Replacement of THT01392 and BAS00986 with THT01408 and BAS01006

Models: FCCB, FCAB, FCBB, FCIB, FFAB, FFBB, FFIB, FFMB

Literature Order Number	PART-SVN03A-EN
File Number	SV-CAP-Controls-PART-SVN03-0801
Supersedes	New
Stocking Location	La Crosse

Figure 1 — Existing Base

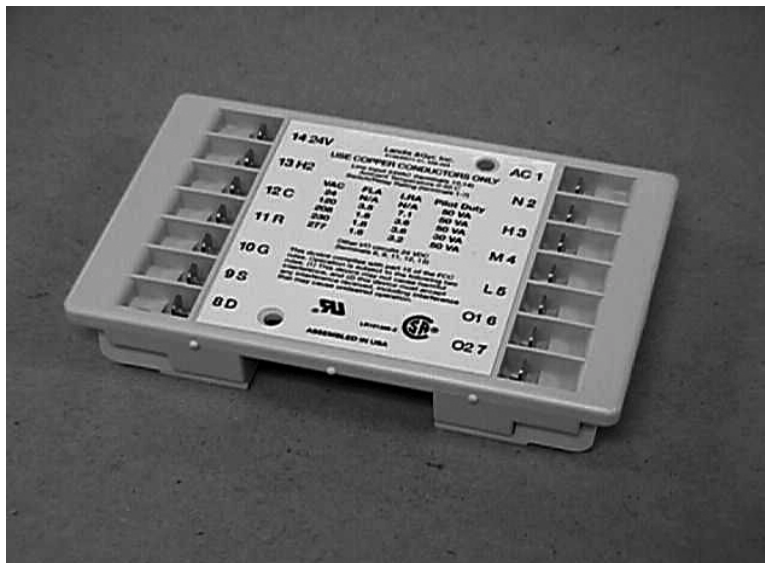
Fan Controller, THT01392, and Base, BAS00986, are no longer available. Fan Controller, THT01408, and Base, BAS01006, are functional replacements, although some minor revisions will need to be made. See the following instructions for installation.

1. Remove controller head from base.
2. Detach the existing pin-connector style base from wall.
3. Mark location of all wires and remove from the existing base. See Figure 1.
4. Install new base on wall. Note that on the new controller, all wires plug directly into the head piece. The base is only used for mounting purposes.
5. If wires going to existing base terminate in female spade type quick connections, simply plug into the same connection number on the new controller head. If the wires are stripped, female spade connectors must first be installed on the wires, then inserted into the like number terminal on the new thermostat head. Note that only terminals 1-5 will be used for this controller. Also note that wire 2 (neutral) should go into the slot marked 10-GN. See Figure 2.
6. Install the new head onto the base.
